**COMMUNITY DEVELOPMENT  
DEPARTMENT REPORT**

HEARING DATE: 1/28/2025  
TO: Mayor & City Council  
FROM: Linda Ritter, Associate Planner  
208-884-5533  
lritter@meridiancity.org  
APPLICANT: Benjamin Semple, Rodney Evans and Partners, LLC  
SUBJECT: SHP-2024-0004  
Were Short Plat  
LOCATION: 2945 W. Ustick Road, Located in Section 2 Township 3N, Range 1W, parcel: S1202223011

Short Plat to subdivide an existing parcel consisting of 3.123 acres of land, into two (2) building lots in the R-4 zoning district.

**D. Short Plat (date: 12/13/2024)**

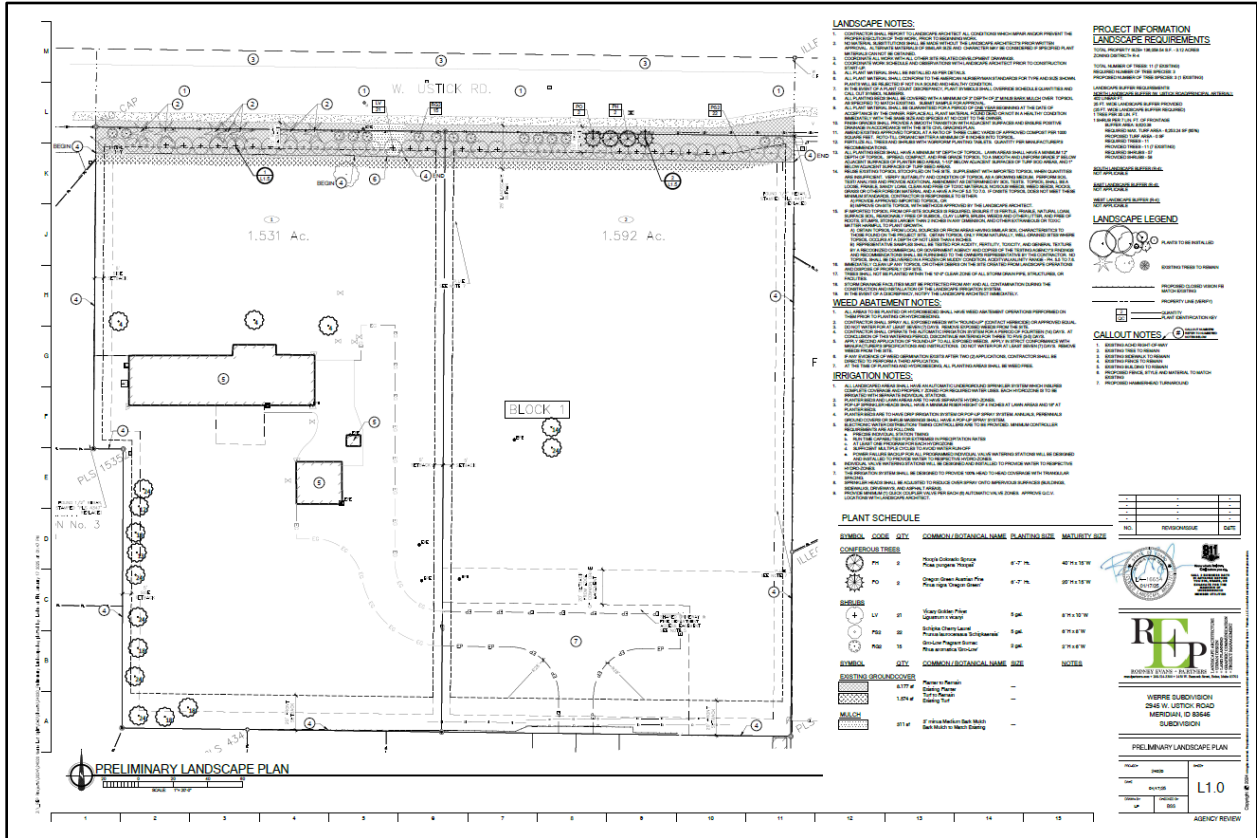
3. Modify the plat to graphically depict the 25-foot landscape buffer along Ustick Road. Add a note to the plat stating the landscaping within the easement will be maintained by the property owners of Lot 1 and 2.

7. Revise the landscape plan to show the existing trees on Lot 2.
8. If the landscape buffer has not been installed prior to ACHD widening of Ustick Road and installation of the multiuse pathway, the applicant shall submit a surety for the landscape buffer prior to City Engineer signature.

9. Revise the landscape plan to show that at least twenty-five (25) percent of qualifying trees are Class 2 selections, unless it can be shown that utility conflicts prohibit installation of Class 2 trees per UDC 11-3B-7-3b.

**F. Common Drive Exhibit (date: 1/17/2025)**

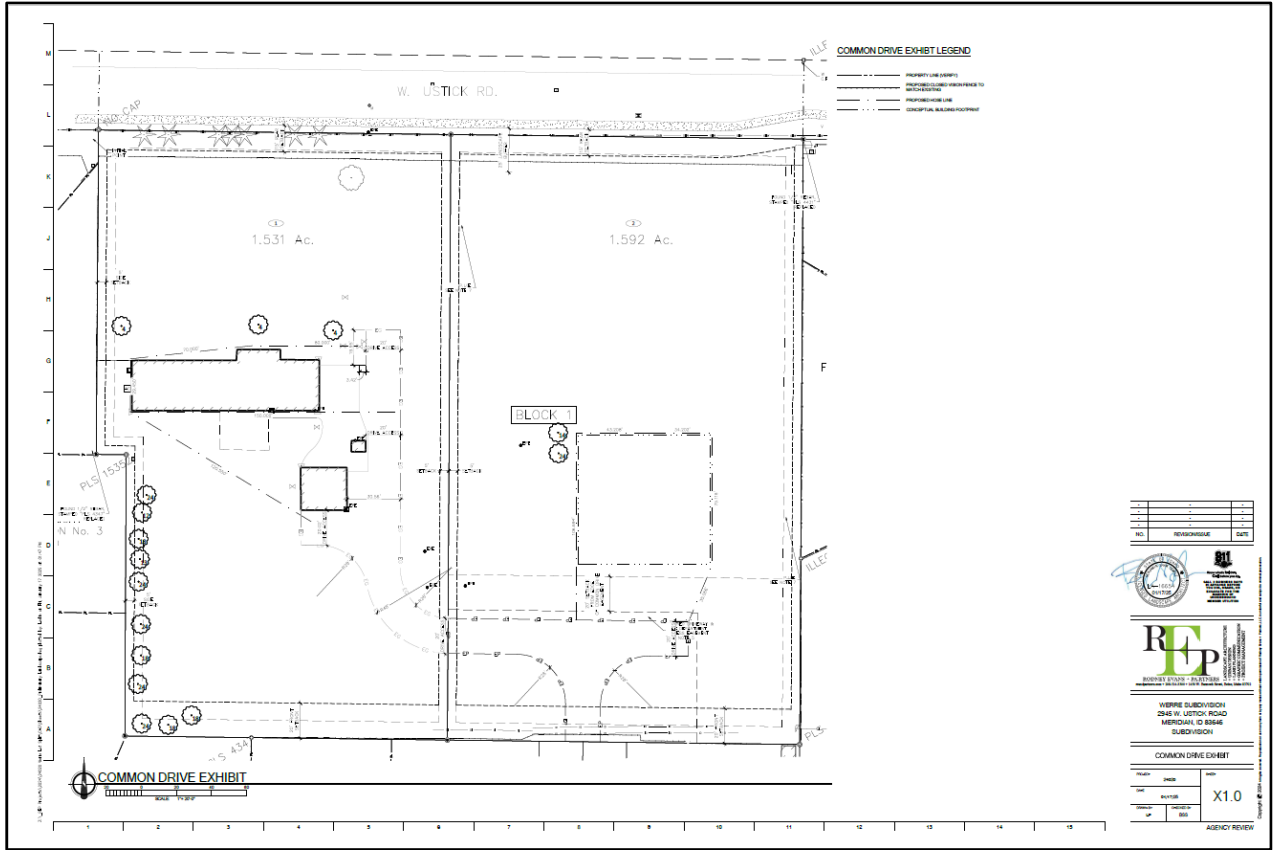
*Access to this property is provided via a shared driveway off N. Morello Avenue. See common drive exhibit in Section VII.F.*

4. Future development shall comply with the dimensional standards listed in UDC *Table 11-2A-5* for the R-4 zoning district and the shared driveway exhibit in Section VII.D.
